Project	IEEE 802.16 Broadband Wireless Access Working Group < http://ieee802.org/16 >	
Title	Corrections on Unsolicited RNG-RSP in Non-transparent RS System under Centralized Scheduling	
Date Submitted	2007-07-05	
Source(s)	Kanchei (Ken) Loa, Yi-Hsueh Tsai, Yung-Ting Lee, Hua-Chiang Yin, Shiann-Tsong Sheu, Youn-Tai Lee,	Voice: +886-2-27399616 Fax: +886-2-23782328 loa@iii.org.tw
	Institute for Information Industry 8F, No. 218, Sec. 2, Dunhua S. Rd., Taipei City 106, Taiwan	
Re:	IEEE 802.16j-07/019: "Call for Technical Comments Regarding IEEE Project 802.16j"	
Abstract	This contribution proposes the modified figures of MS unsolicited RNG-RSP in non-transparent RS system under centralized scheduling scheme based on comment #1141 of 80216j-07_014r4.cmt.	
Purpose	Text proposal for 802.16j Baseline Document.	
Notice	<i>This document does not represent the agreed views of the IEEE 802.16 Working Group or any of its subgroups. It represents only the views of the participants listed in the "Source(s)" field above. It is offered as a basis for discussion. It is not binding on the contributor(s), who reserve(s) the right to add, amend or withdraw material contained herein.</i>

Correction on

Table 201x—Unsolicited RNG-RSP triggered by uplink traffic in non-transparent mode

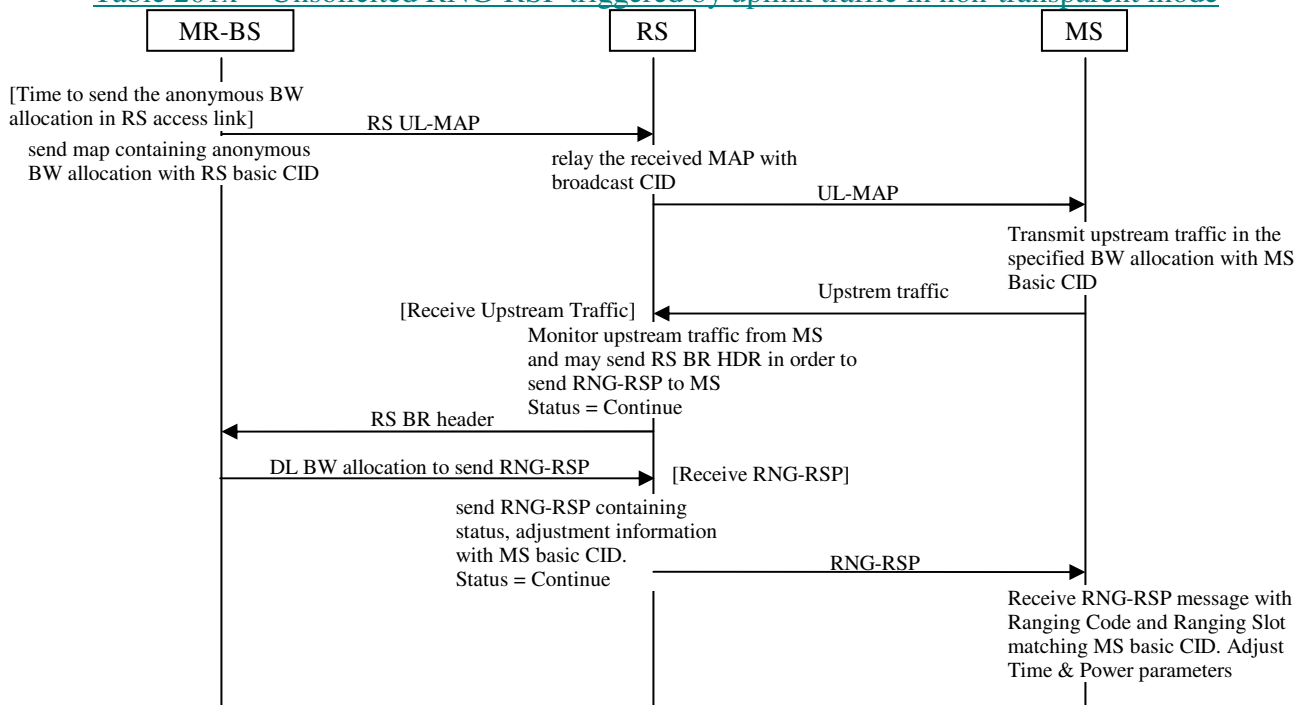
[Inserted the following Table in page 101 as indicated]

Figure 108x—Unsolicited RNG-RSP triggered by upstream traffic in non-transparent mode at Access non-transparent RS

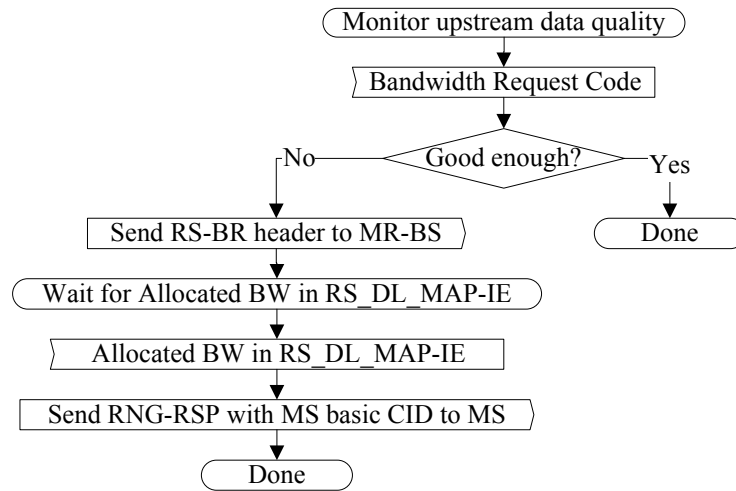
[Inserted the following figure in page 101 as indicated]
